Crackajack Federal Com #1

Legal Description: 800' FSL & 1980' FWL, Sec. 3-T25S-R25E

PECOS DISTRICT CONDITIONS OF APPROVAL

Marbob Energy Corporation
LEASE NO.:	NM62171
WELL NAME & NO.:	Crackajack Federal Com No. 1
SURFACE HOLE FOOTAGE:	800' FSL & 1980' FWL
BOTTOM HOLE FOOTAGE	'FL&'FL
LOCATION:	Section 3, T. 25 S., R 25 E., NMPM
COUNTY:	Eddy County, New Mexico

Figure 1 – Cross Sections and Plans For Typical Road Sections

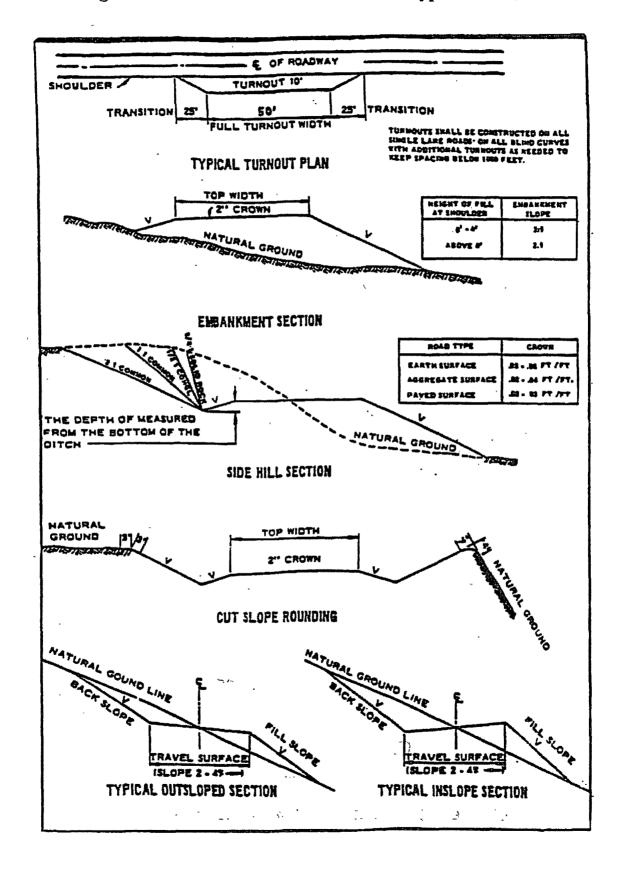
Crowning shall be done on the access road driving surface. The road crown shall have a grade of approximately 2% (i.e., a 1" crown on a 14' wide road). The road shall conform to Figure 1; cross section and plans for typical road construction.
